INDESIT company

AV41EX50-60

ARISTON INDESIT Scholtès

Fig . 001

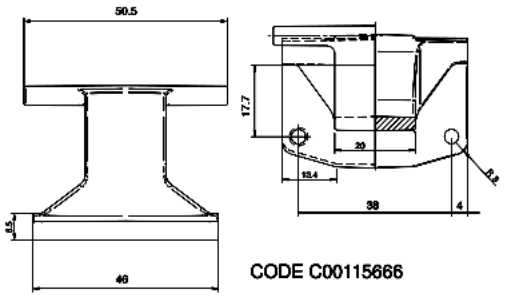
n1040349: Introduction of 150° Zamac hinge on Ariston 46 models.

From serial no. 50207.0001, all Ariston models produced in the Teverola factory (see table 001 attached) with industrial code (given on the rating plate) starting with 46, have been equipped with a Zamac hinge with 150° opening angle, code C00115666 (see Fig.001).
This modification has involved the introduction of the following items:

Code C00115670 - Complete door EVOII 150° white 27 with standard glass;
Code C00115674 - Complete door EVOII 150° white 27 with long glass;
Code C00115667 - EVOII body for 150° hinge white 27;

The premodified items are not interchangeable separately with the modified ones.

Code C00110133 - Complete door EVOII Standard 180° white 27 standard glass;
Code C00092157 - Complete door EVOII 180° white 27 long glass;
Code C00096193 - EVOII body for 150° hinge white 27;

The hinge code C00064541 continues to be used on the build-under models produced in the Comunanza factory.
